## CPUC - CEQA dEIR for RTRP

This letter is written in response to the Subsequent Draft Environmental Impact Report (SDEIR) for the Riverside Transmission Reliability Project. The proposed project involves the construction of transmission line structures, electrical substations, and upgrades to existing substations and telecommunication facilities. The proposed project is located in Riverside County within the cities of Jurupa Valley, Norco, and Riverside.

Re: Review and Comment – Draft Subsequent EIR Riverside Transmission Reliability Project

**Figure 1**      **Revised Project Elements**

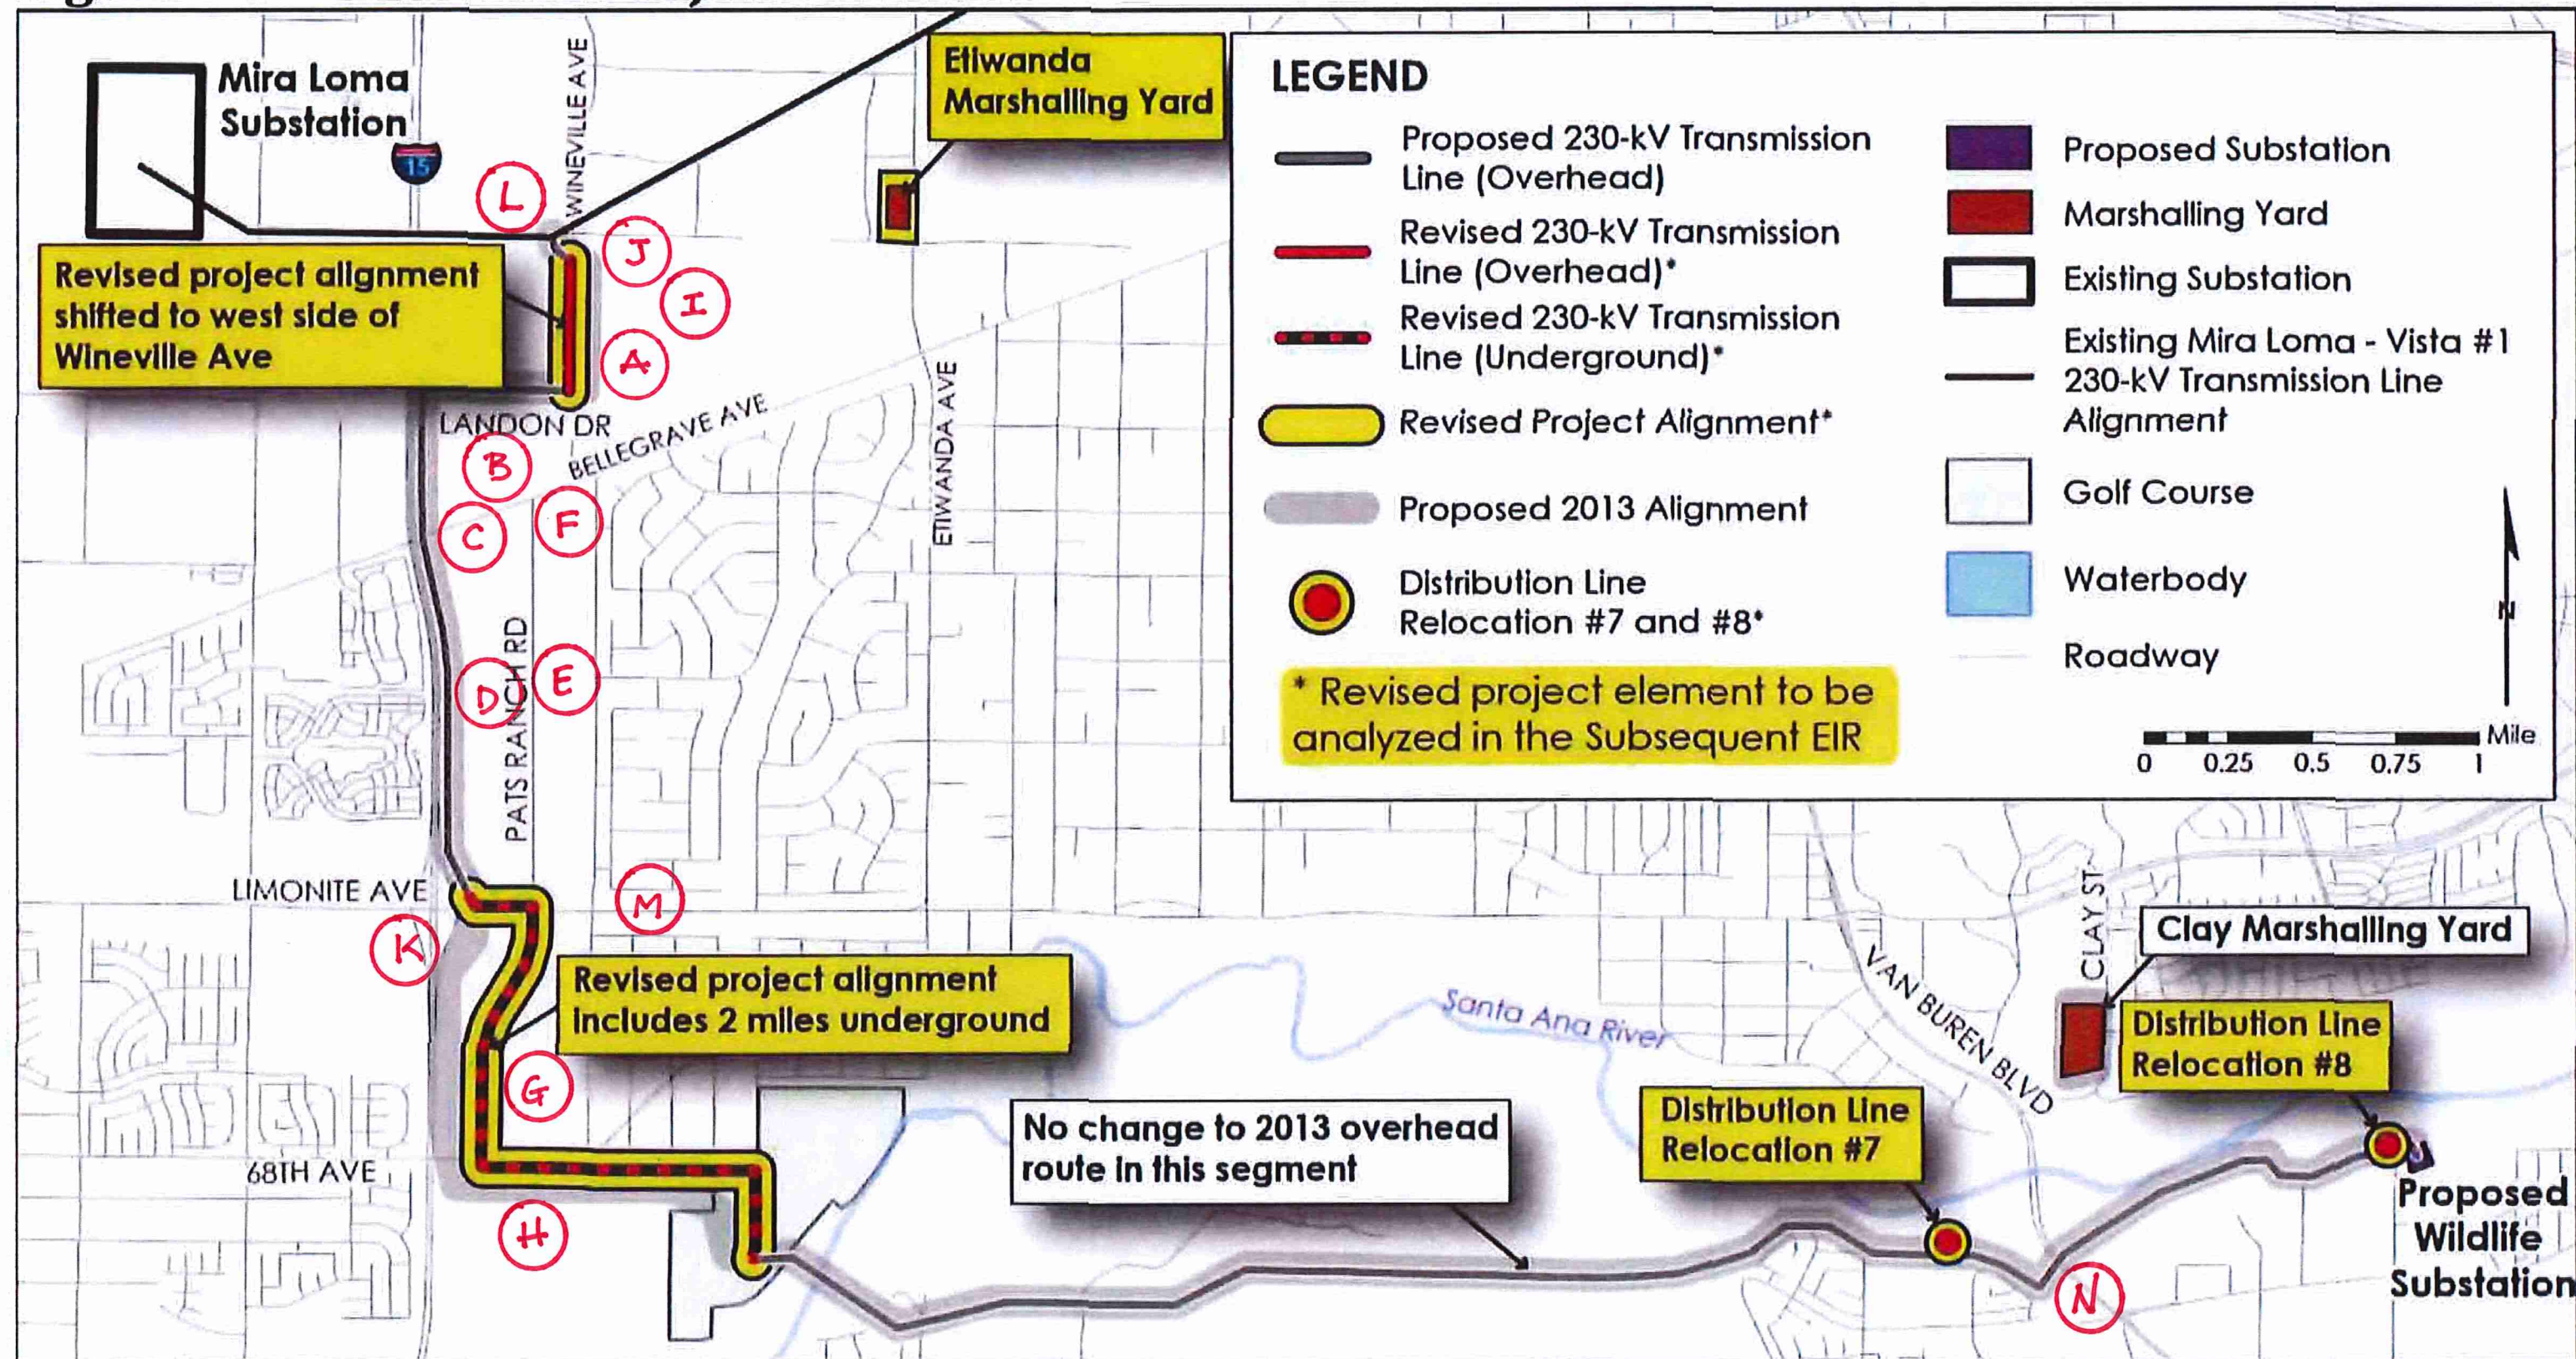
The proposed RTRP alignment, which encompasses the Hidden Valley Wildlife Area Boundary Change, crosses several existing, current or proposed projects where the proposed RTRP 100-foot overhead right-of-way or underground alignment may encroach upon, or interfere with senior rights and/or incompatible usage; please see attachments provided.

**Figure 2 – Modified Alternative 26**

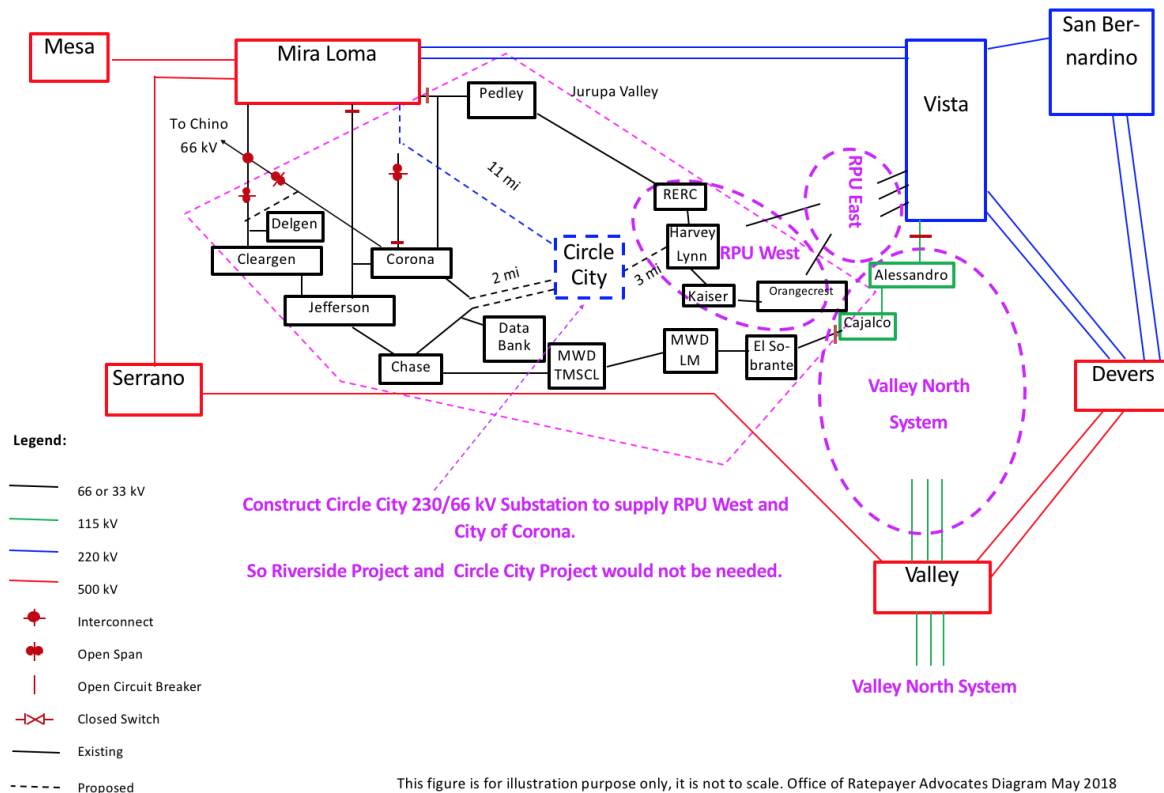
Based on this new information, Alternative 26 should be modified ( Modified Alternative 26)<sup>8</sup> to eliminate the need to construct the 27 mile 115kV transmission line. (See Figure 2) ORA's Modified Alternative 26 would construct the Circle City Substation as a 230/66 kV Substation instead of constructing SCE's proposed 66 kV Substation. The Circle City Substation would interconnect to the Mira Loma Substation, which is in the City of Ontario, with approximately 11 miles of 230 kV transmission lines. Then the Circle City Substation would connect to Riverside with a 66 kV transmission lines to serve the RPU's load.

ORA recommends that Modified Alternative 26 be evaluated in the Final Subsequent Environmental Impact Report (FSEIR) to consider the potential approval of Valley-Ivyglen Substation. Modified Alternative 26 meets the basic project objectives, meets the regulatory feasibility criteria, and reduces environmental impacts as discussed below. In addition, ORA recommends the Commission evaluate another bulk transmission alternative (Proposed Bulk Transmission Alternative, see Figure 3) in the FSEIR as discussed below.
